COUNTY ADMINISTRATOR'S OFFICE

Re: **2017 Addendum to Water Quality Permit, Rosemont Copper Project ACOE
Application No. SPL – 2008-00816-MB**

This letter responds to the call for public comment regarding the proposed Addendum to the State's 401 Certification (Certification) to the U. S. Army Corps of Engineers (Corps) Section 404 for the Rosemont Copper Mine. The State proposes to amend the Certification to include mitigation for the mine's impacts to Waters of the U.S. The mitigation proposed includes the Sonoita Creek mitigation project, the San Pedro In Lieu Fee (ILF) program, and the removal of certain stock tanks on the Rosemont Project site. We object to this Certification on a variety of grounds, some of which we have previously stated, and others which are new.

Figure 1. In red, areas of former mine-related activities based on cultural resource surveys. Drill holes in yellow. Location of stock tank removals shown in green and are approximate.

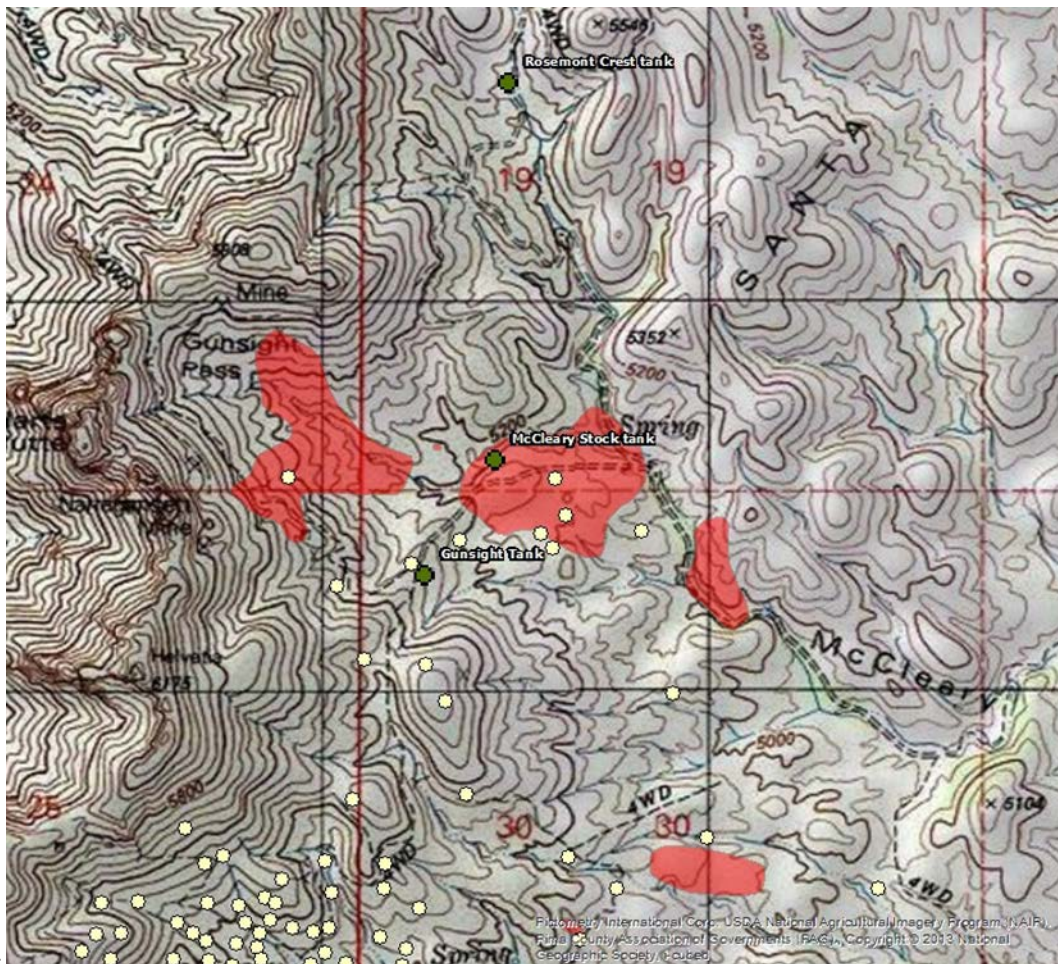
Rosemont is proposing to eliminate four dirt tanks within the project footprint to allow stormflow to be conveyed downstream. In two of the watersheds (McCleary Stock Tank and Gunsight Tank) there has been historical mining activities (see map below; red areas are historic mining sites as determined from cultural resource surveys and yellow dots are historical drill holes). The impact of disturbing soils associated with these features and conveying unknown—and unanalyzed—contaminants downstream has not been analyzed as part of the Biological Opinion or FEIS.

Hubday (2015) data show that under current conditions, which include numerous mining features and land disturbance upstream, base flows of springs are of good quality. Elevated levels of dissolved copper, and total lead and copper have been consistently observed in stormwater at monitoring site PSW-4. Upstream spring flow met the livestock standards (Tetra Tech memorandum dated May 5, 2009). Would release of stored sediment increase ambient metal concentrations? Further study is warranted before the state can draw a conclusion that existing uses will not be impaired by the dredge-and-fill activities upstream, which include the stock tank removals. The stock tanks in the upper McCleary watershed are located below old mining claims which were historically worked (Figure 1).

Figure 2. This aerial photograph, dated April 2016, shows intermittent stream flow downstream of McCleary diversion dam. Additional spring and in-stream flow uses occur upstream.

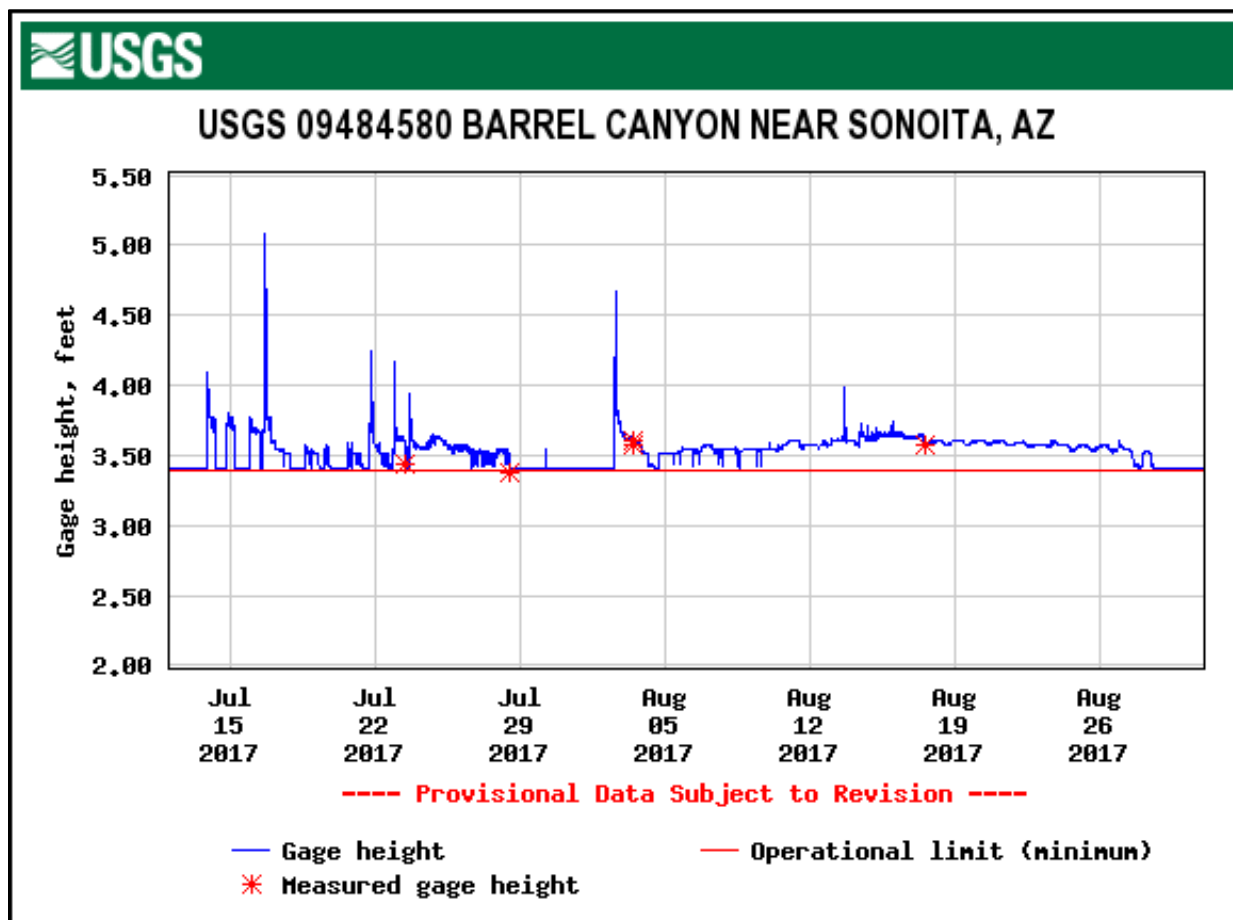
Intermittent flow in McCleary includes two discharging springs and streamflow upstream and downstream of a diversion dam near latitude 32.3344 degrees north and 110.972 degrees west (Figure 2). Errol Montgomery and Associates measured flow at the McCleary dam during every month for two consecutive years, establishing the perennial nature of the discharges below the dam. In 2010, a pipe was installed at the dam to feed cattle troughs. (See Rosemont-67 East Side Information Summary of Groundwater Level Measurements for Wells, Piezometers and Drill Holes and Monitoring Date for Seeps and Springs.) Water quality samples were obtained by Montgomery and Associates during May and June, as well as other months of the year, again demonstrating the presence of perennial or near-perennial water in this stream.
